PROGRAM INFORMATION BULLETIN NO. P09-01

SUBJECT: Potential Safety Hazard on J. H. Fletcher & Co. Roof Bolting Machines
with Independent Left and Right Tram Levers

Figure 1 (Tram Control Valve)

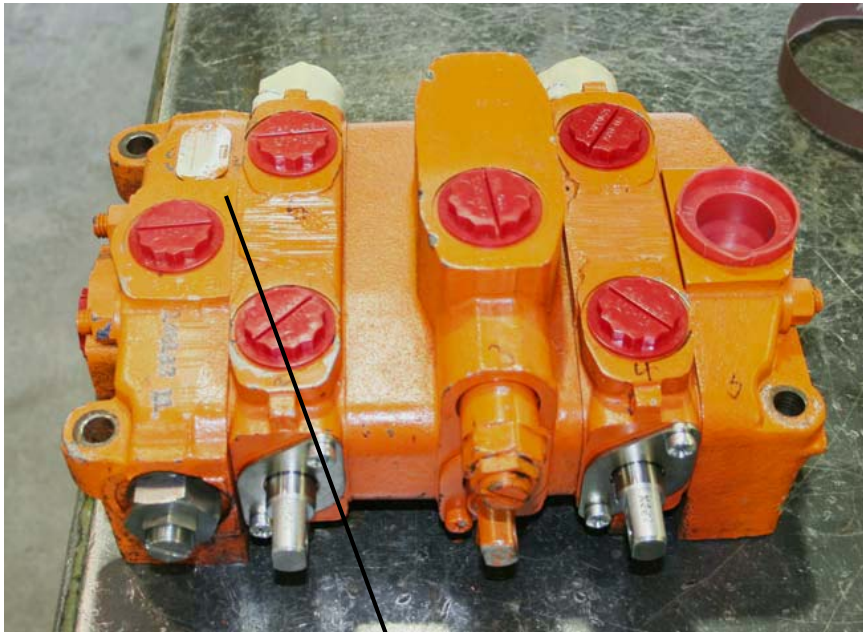
- 1: The part number on the tram control valve will be 148133-11 instead of 148133-00. Reference Figure 1 and Figure 2 below.
- 2: The date code in the serial number will be later than the population of suspect tram control valves (H0608-XXXX or later). Reference Figure 1 and Figure 2 below.

Will be "11"

Figure 3
(Tram Control Valve)

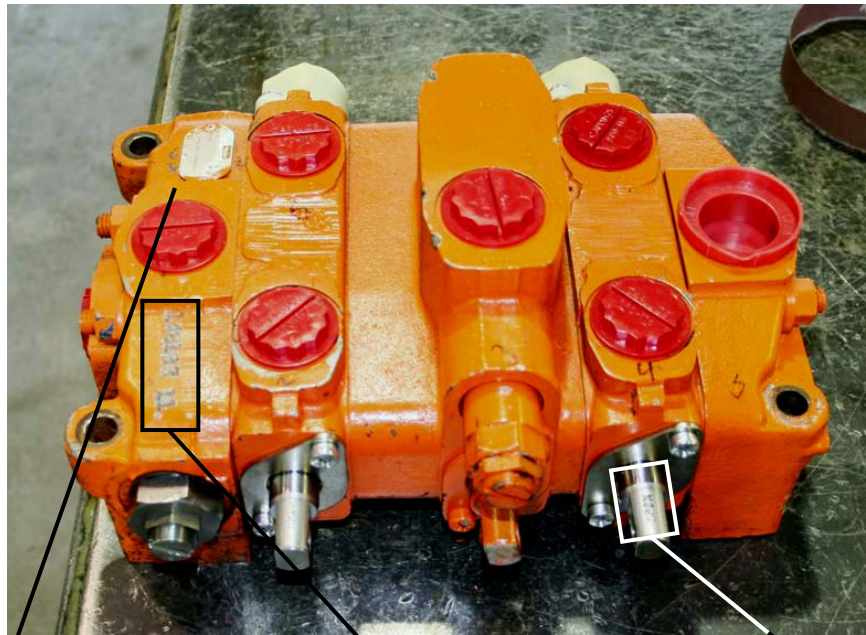
- 1: The new part number "148133-11" will be stenciled on the tram control valve body. Reference Figure 3 and Figure 5 below.

- 2: If the original tram control valve tag is present, "11" will be stamped over the "00" at the end of the part number. Reference Figure 3 and Figure 4 below.
- 3: The new spools are stamped with "159X" on the handle end of the spool. Reference Figure 3 and Figure 6 below.
